STEREO CASSETTE-CORDER

TC-158SD

CORRECTION

No. 1
December, 1976

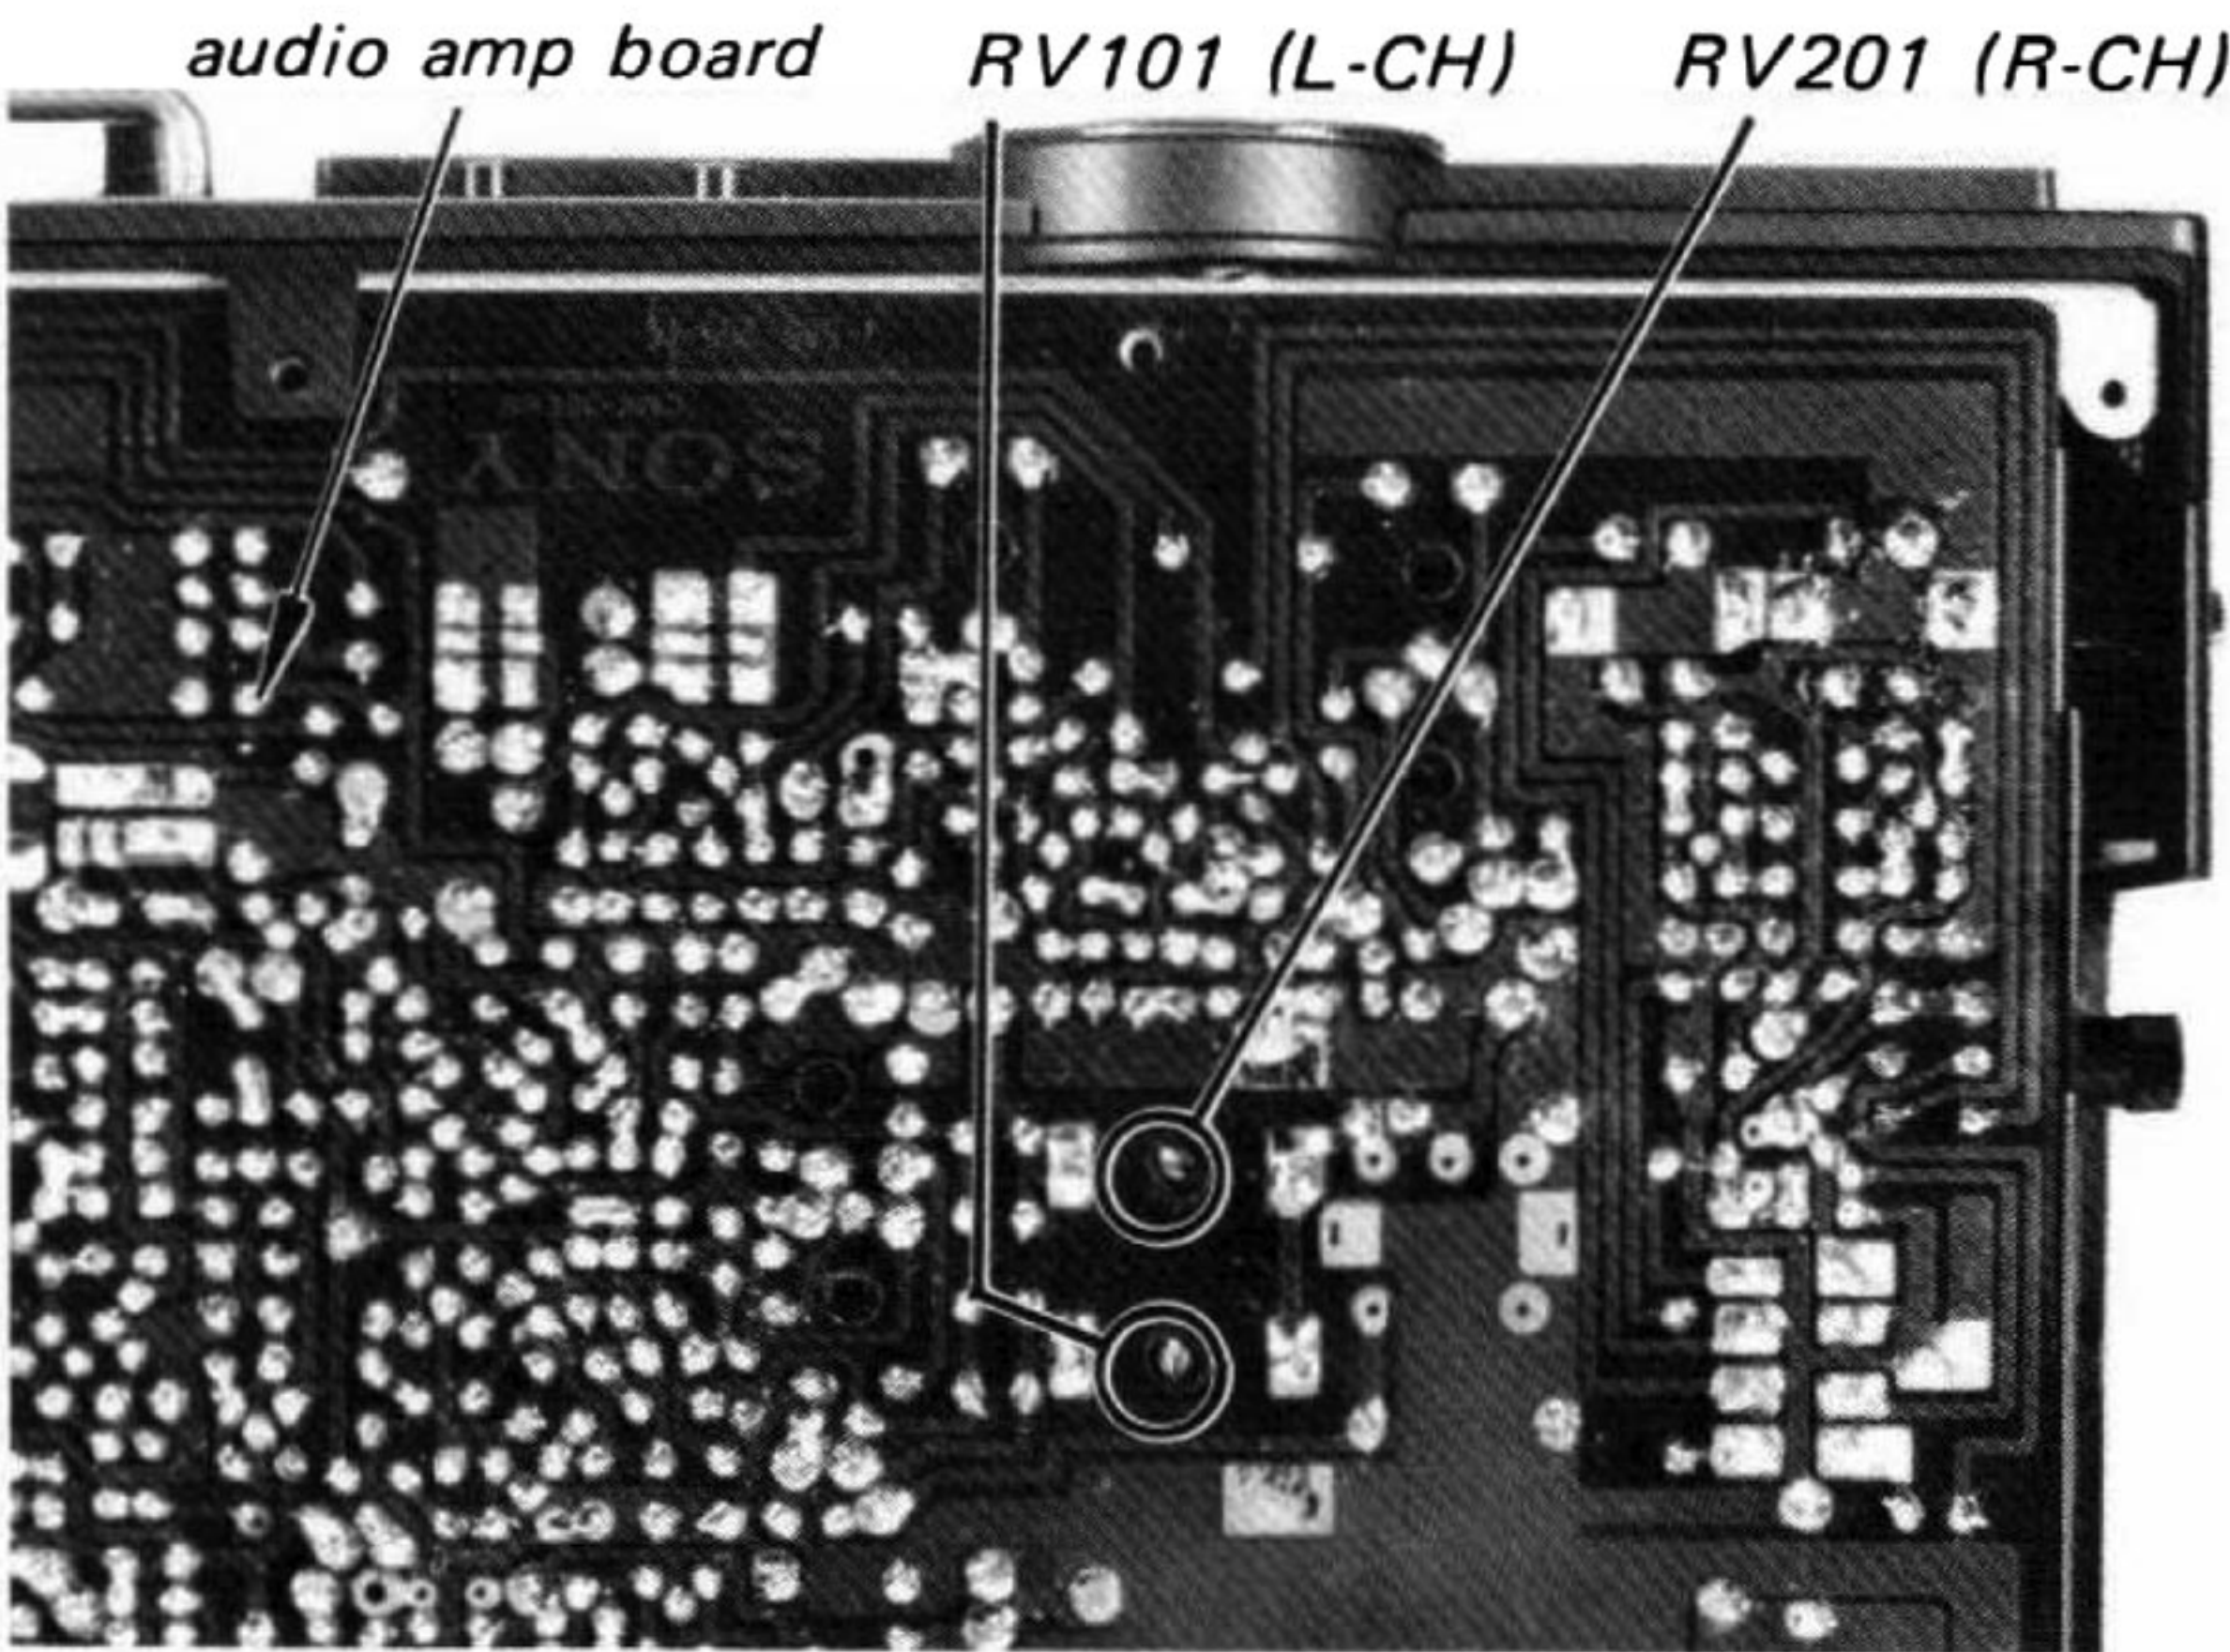
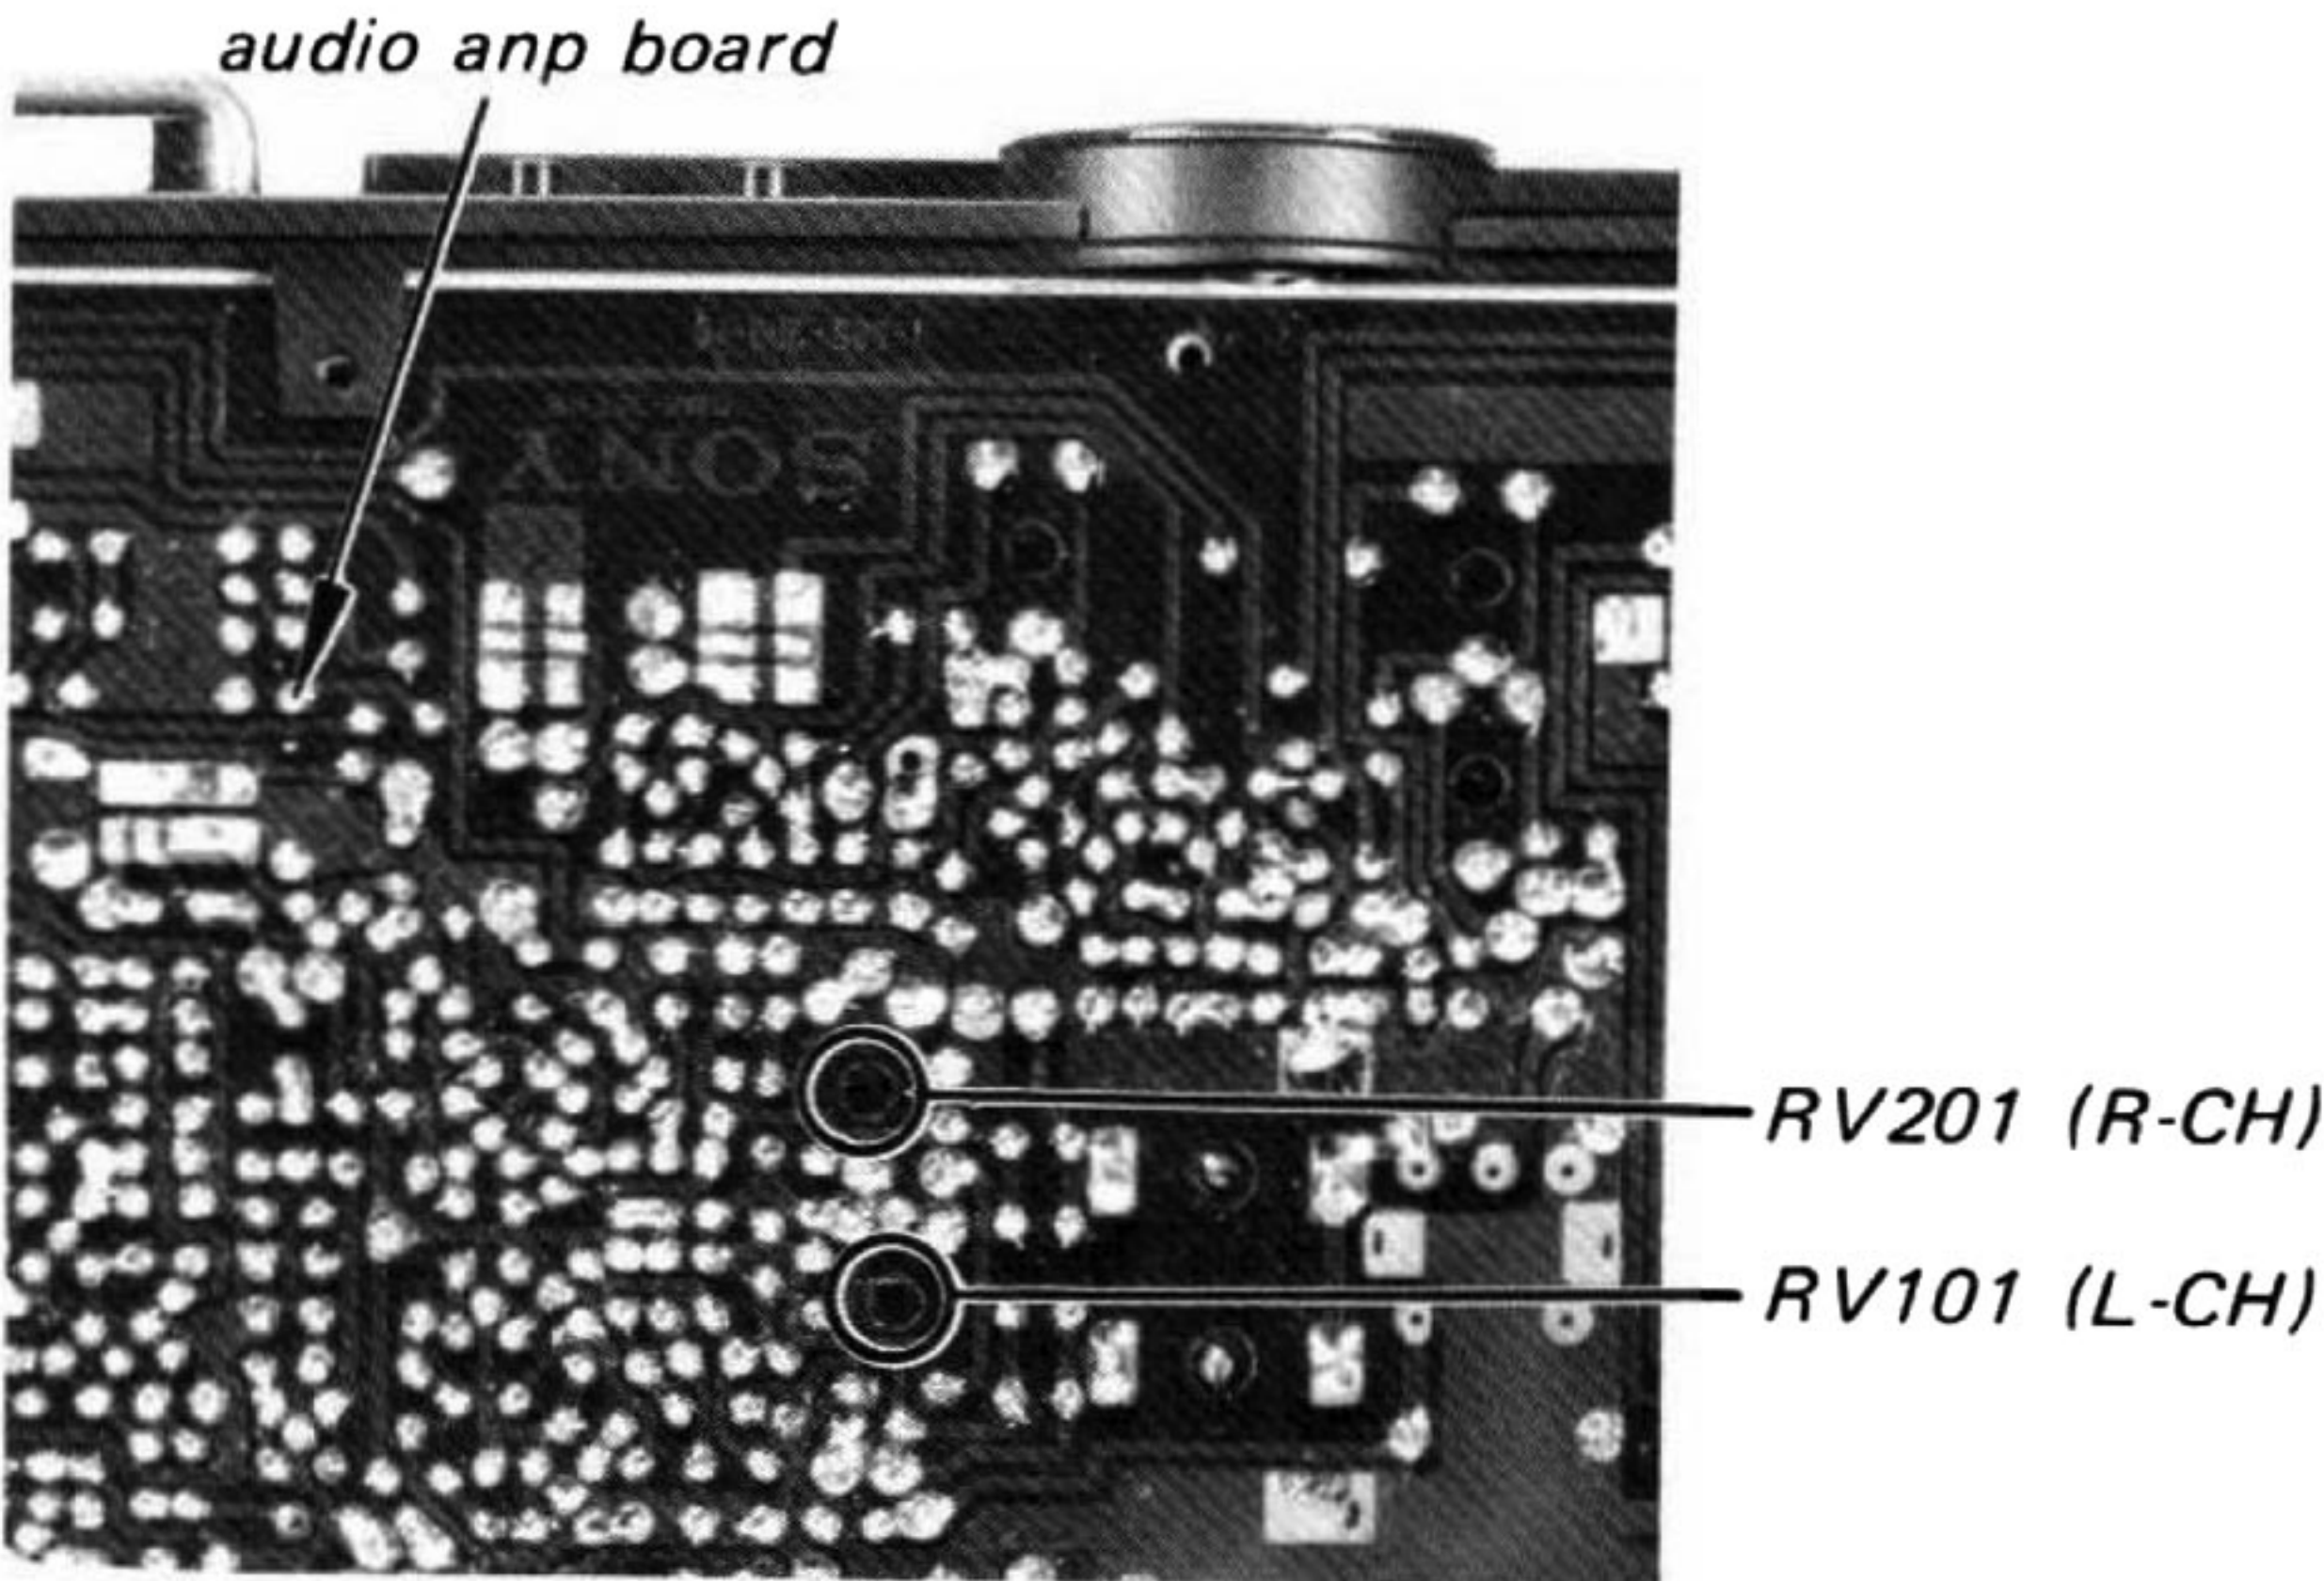
Correct the service manual as shown below.

Incorrect	Correct
Adjustment Location:  The diagram shows the audio amp board with labels for 'audio amp board', 'RV101 (L-CH)', and 'RV201 (R-CH)'. The adjustment points are indicated by circles on the board.	Adjustment Location:  The diagram shows the audio amp board with labels for 'audio amp board', 'RV201 (R-CH)', and 'RV101 (L-CH)'. The adjustment points are indicated by circles on the board.
